AR-07-1162

Southern Nuclear Operating Company
Vogtle Early Site Permit Application
Supplemental Response to Requests for Additional Information on Geology/Seismology

Supplemental Response to Geology/Seismology RAIs

Vogtle ESP Application

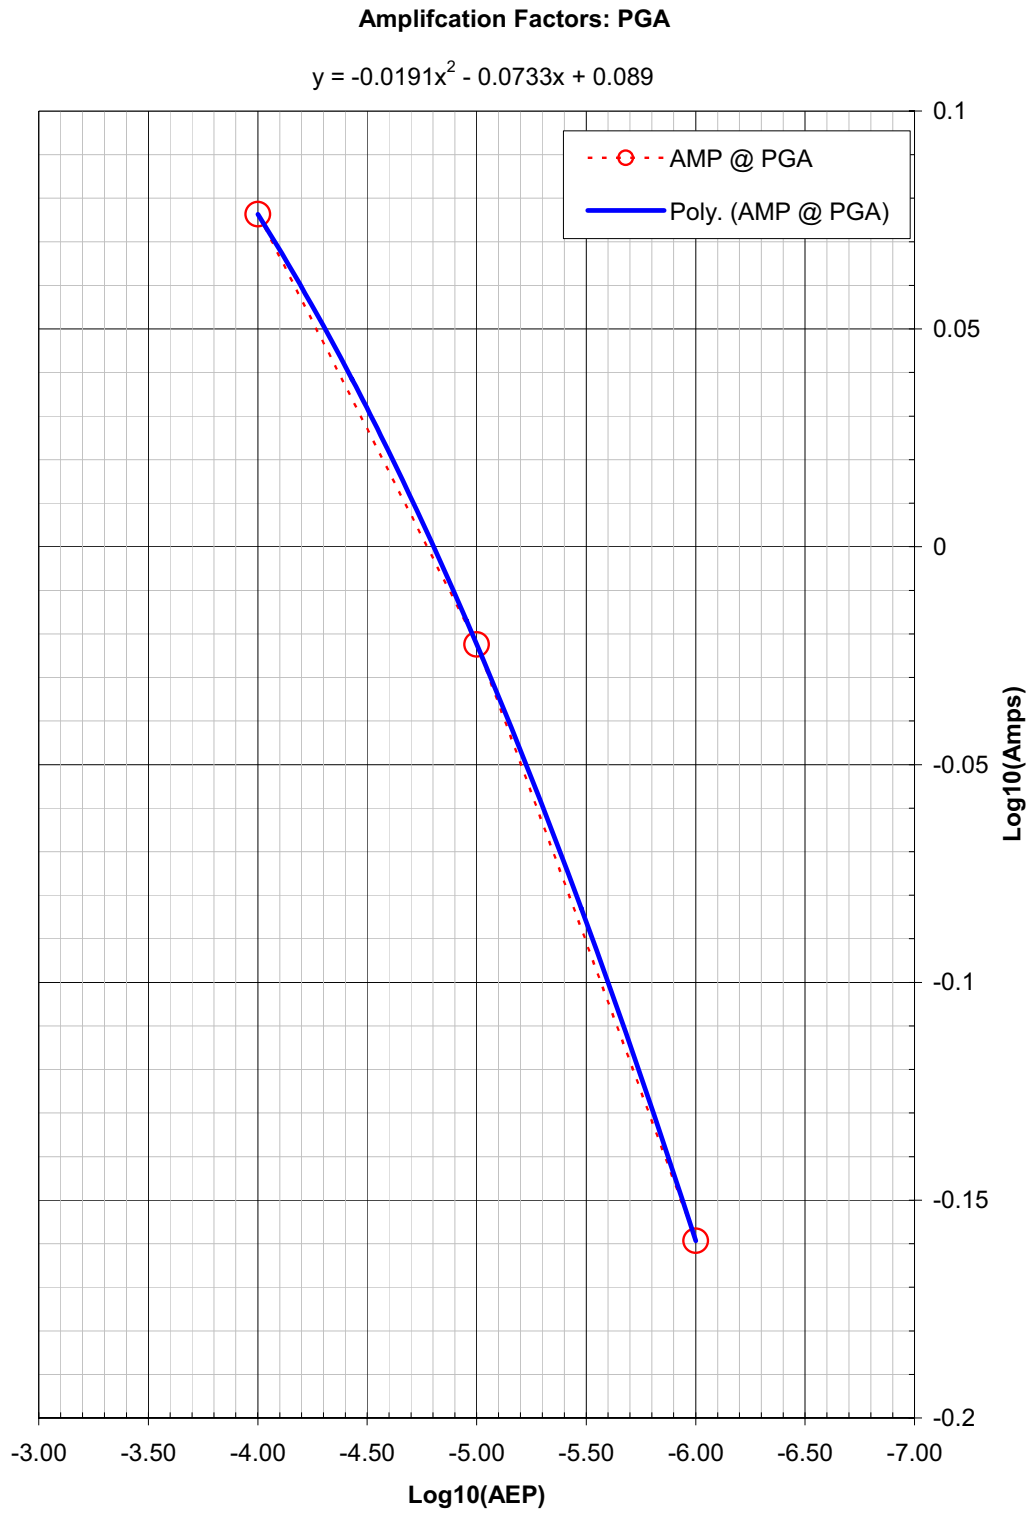
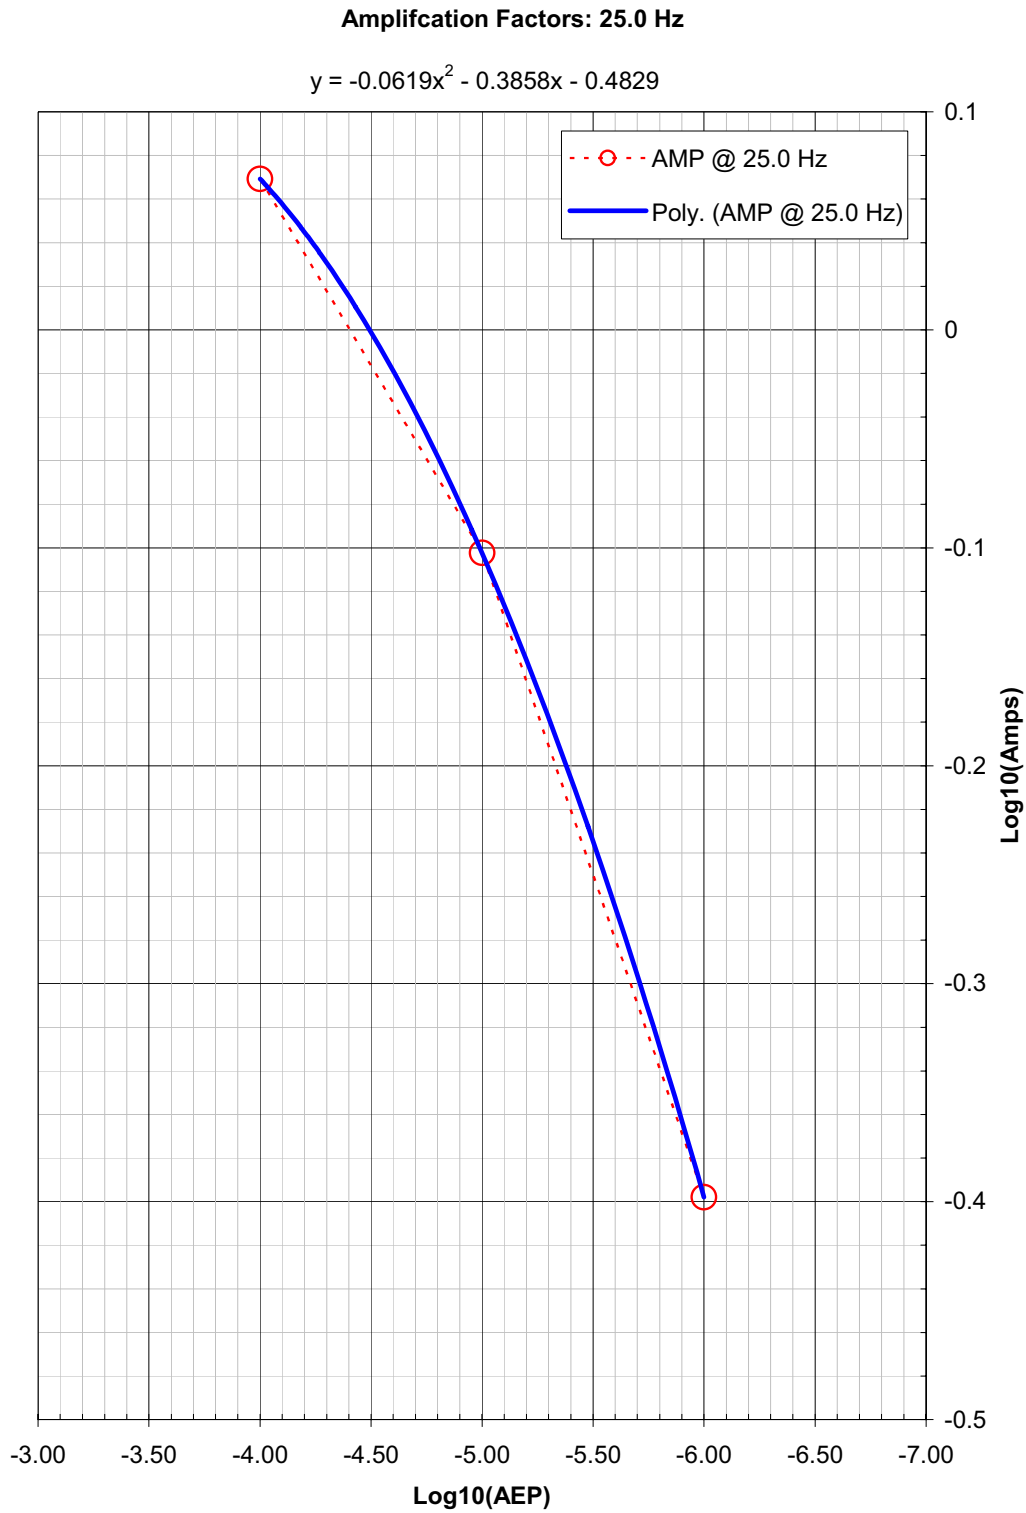
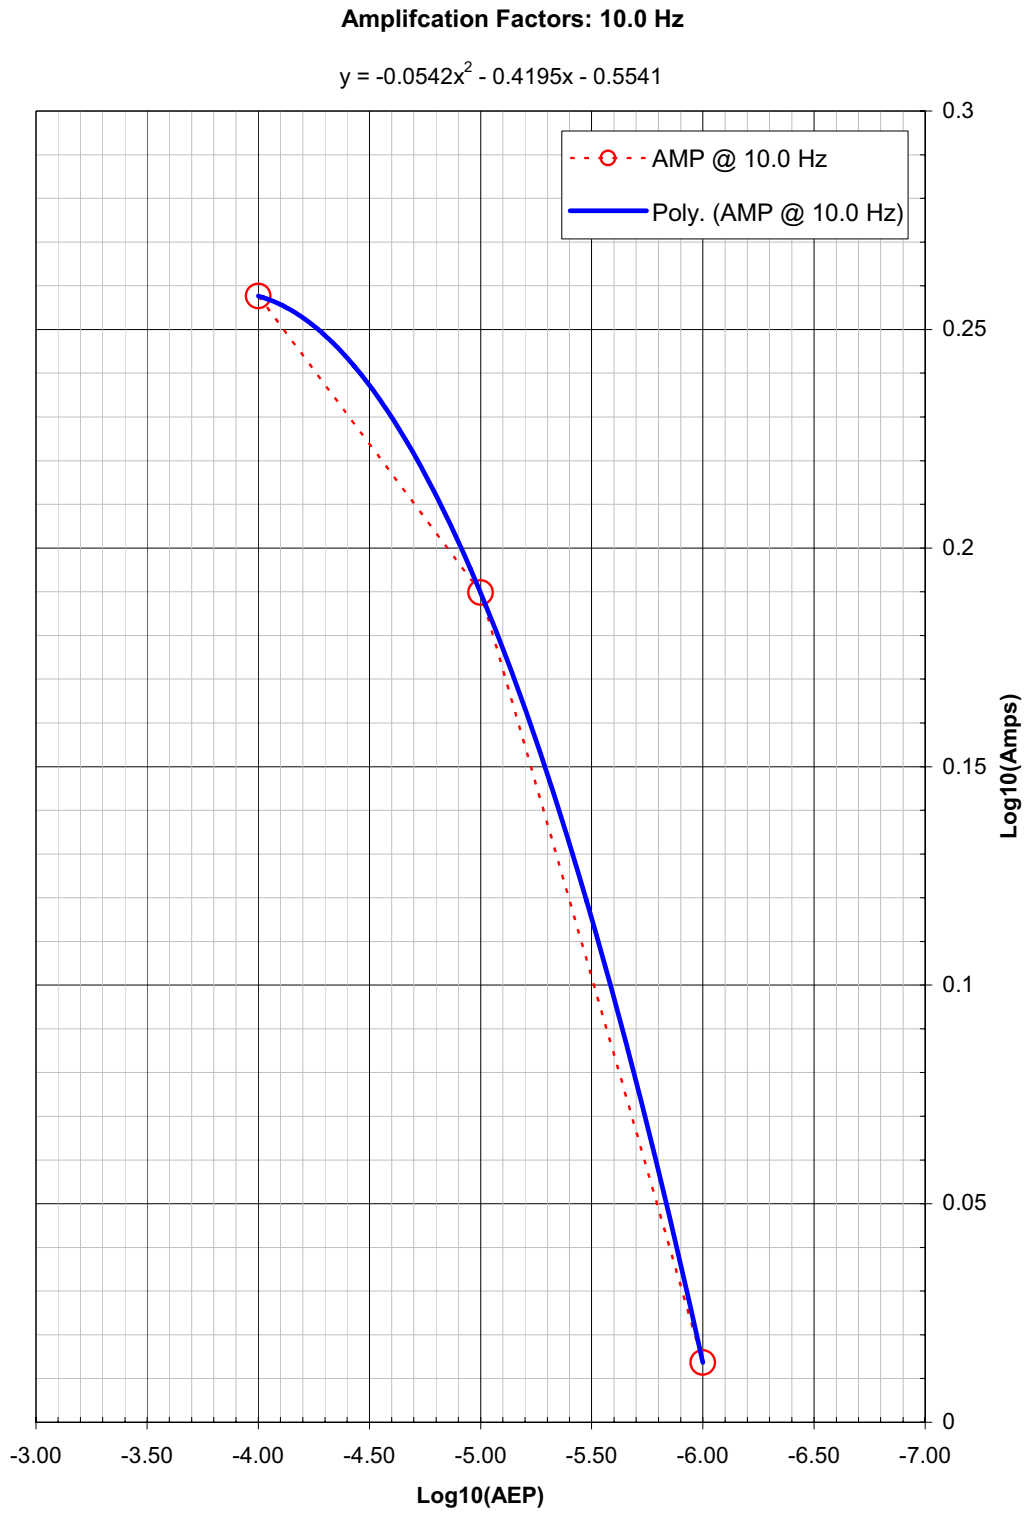
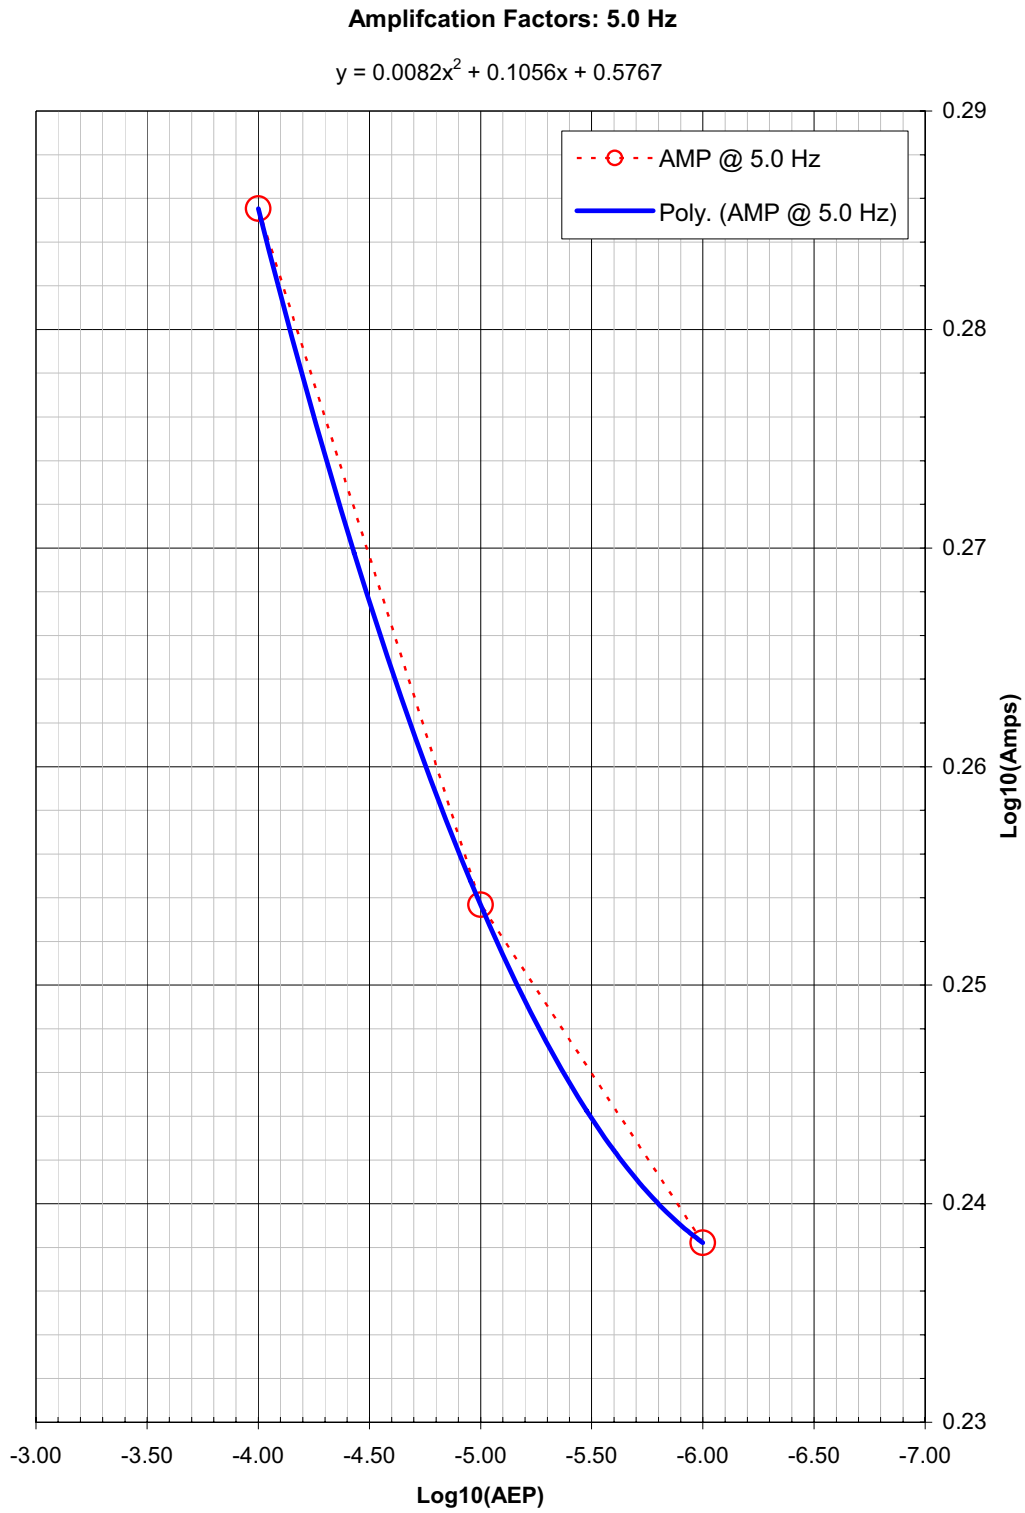
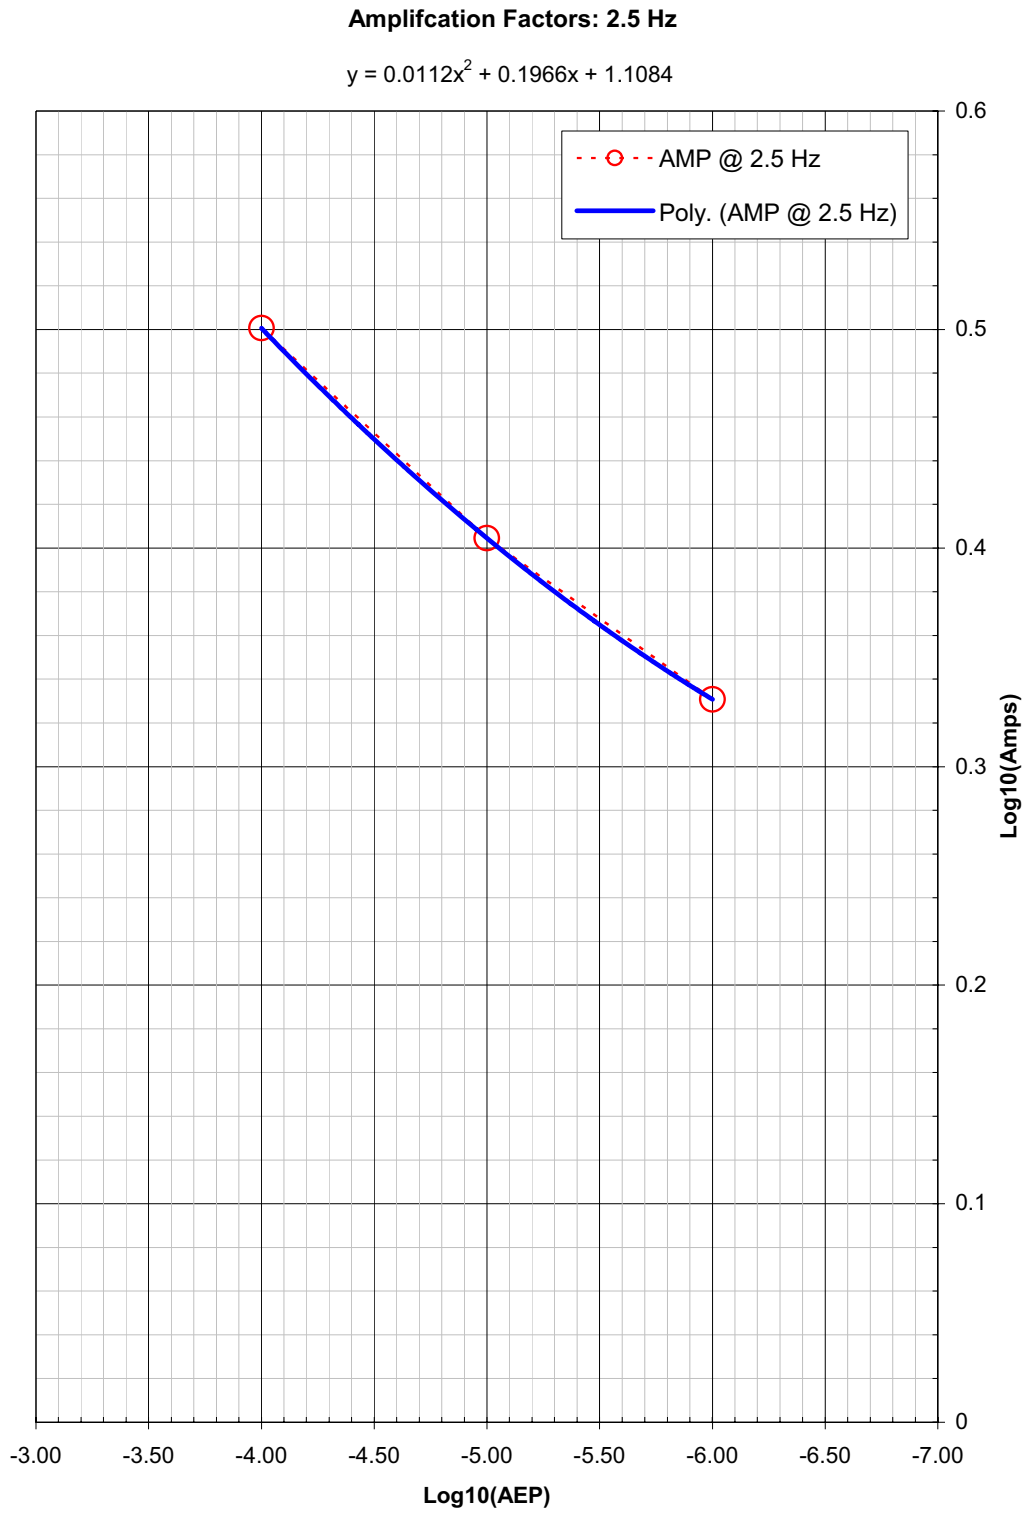
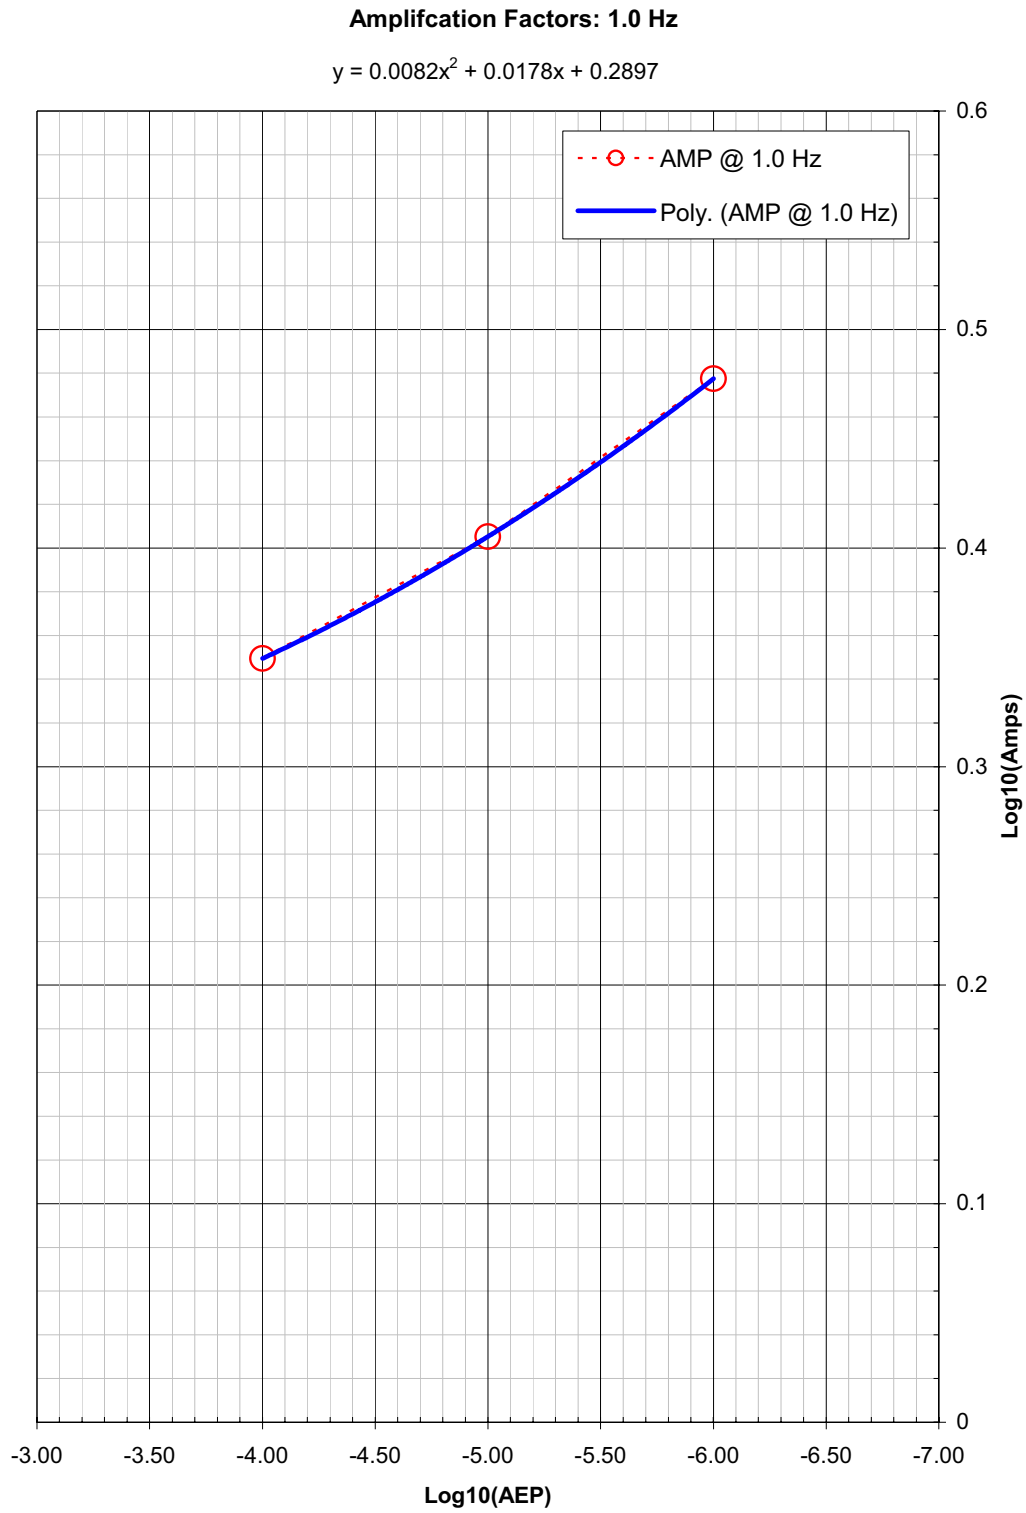
2.5.2-3 In response to this RAI, soil hazard curves were provided at three annual exceedence frequencies (10^{-4} , 10^{-5} , and 10^{-6}). However, in order for the staff to verify the adequacy of the SSE, soil hazard curves are requested at additional annual exceedence frequencies (i.e. at values between 10^{-4} , 10^{-5} , and 10^{-6}).

For each of the seven frequencies a quadratic equation was fit to the log (base10) of the spectral ratios (AMP) as a function of the log (base10) of the annual exceedence probability (AEP). Mathematically, this functional model is given as,

The resulting fits to the three data points are shown in Figure 1, located on the following pages, for each of the seven frequencies. The coefficients and equation are given at the top of each plot. Note that the red dashed line is a linear log-log line between the three data points.
